Claystone Court Subdivision Replat A

City of El Paso — City Plan Commission — 9/6/2018

SUSU18-00071 — Resubdivision Combination - **REVISED**

ATTACHMENT 2

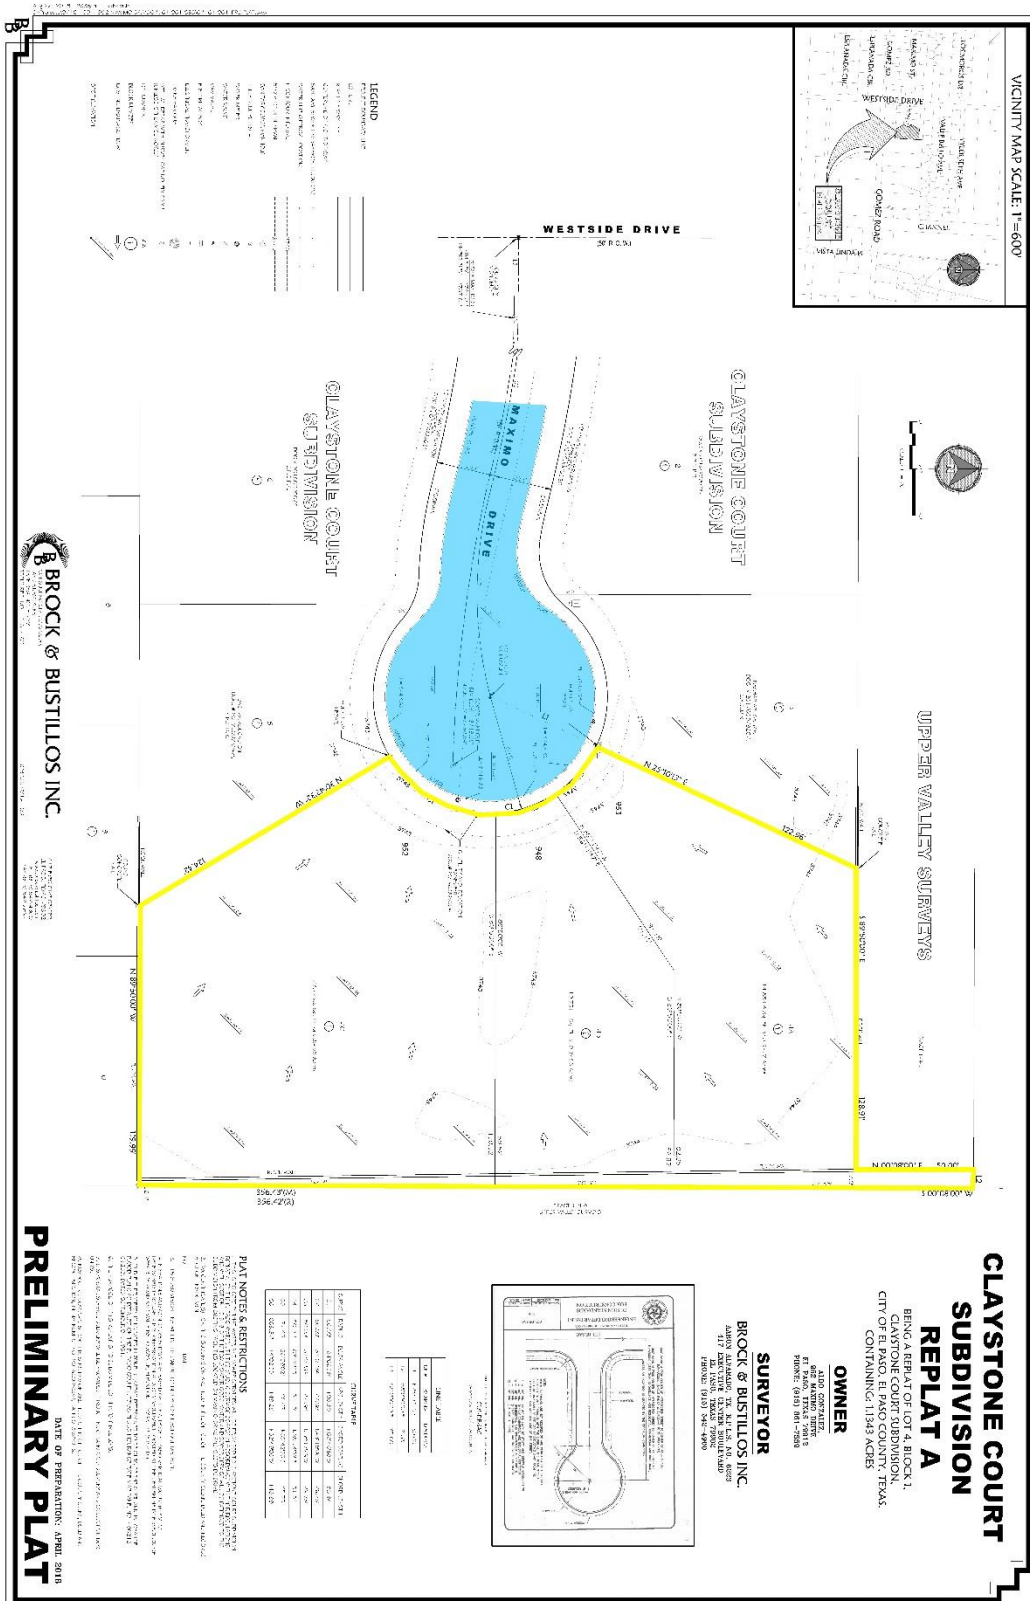
- 1: Add to general notes: All storm water runoff shall be addressed within the subdivision boundaries, lots shall be subject to on-site ponding.
- 2: Show proposed runoff arrows flowing towards lots and add symbol on key legend.

ATTACHMENT 3

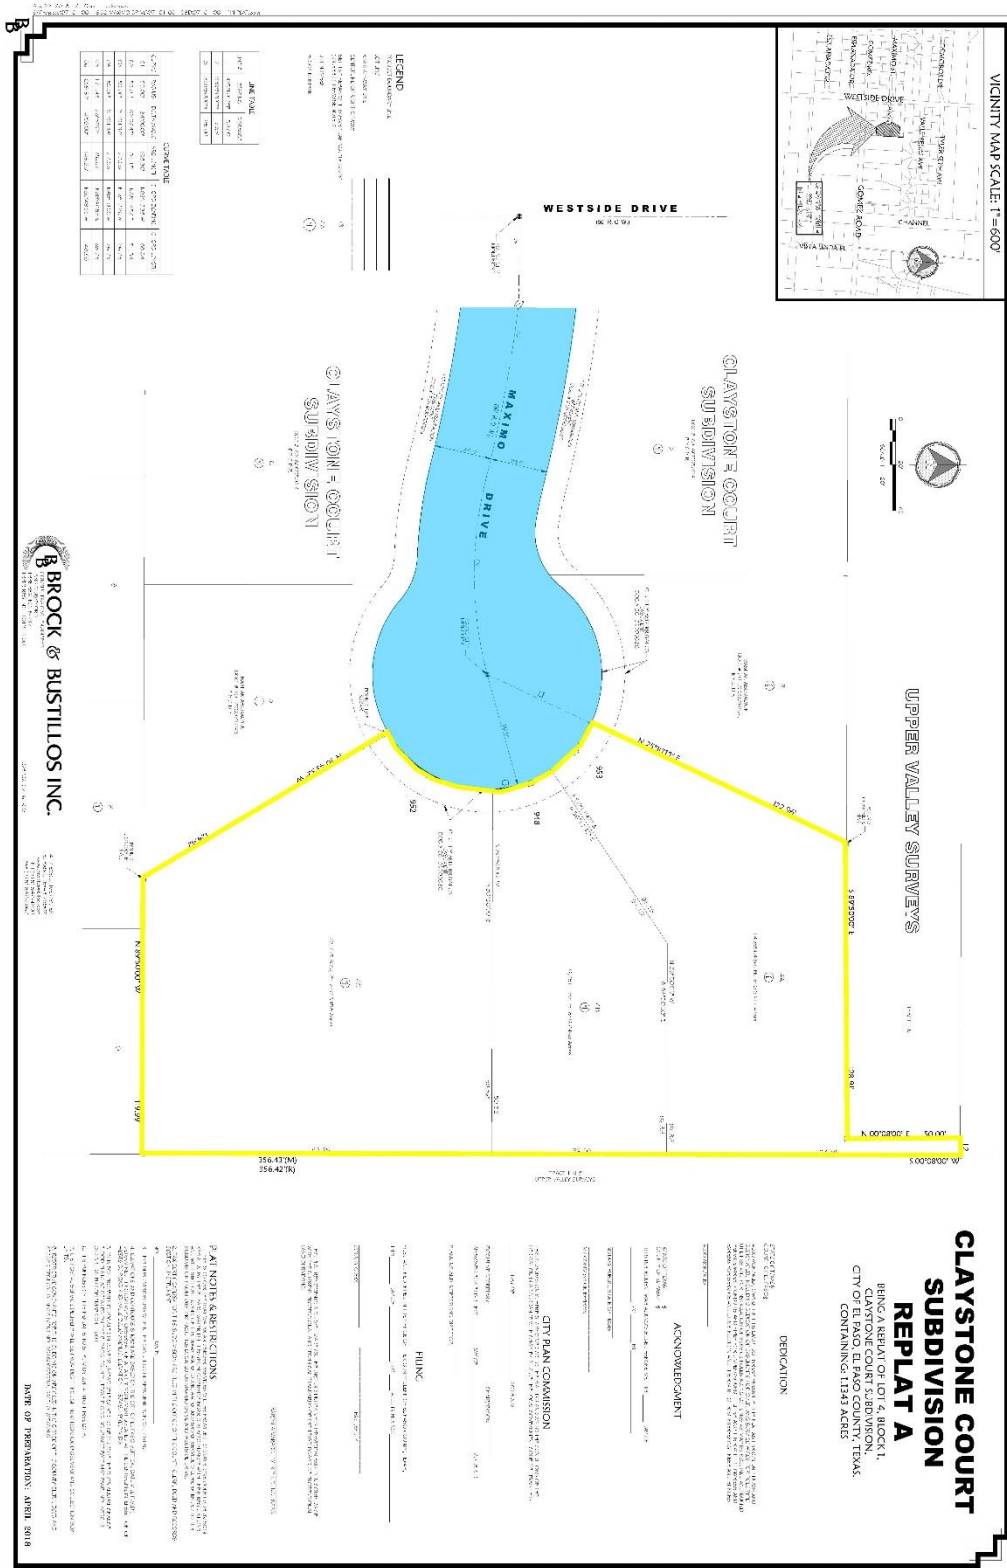
~~The applicant must submit a cross section for the cul-de-sac and include a 10' utility and sidewalk easement in accordance with the cul-de-sac DSC standard, as the radius of the cul-de-sac is 50'.~~
No objections to proposed subdivision.

~~3: The applicant must submit a cross section for the cul-de-sac and include a 10' utility and sidewalk easement in accordance with the cul-de-sac DSC standard, as the radius of the cul-de-sac is 50'.~~
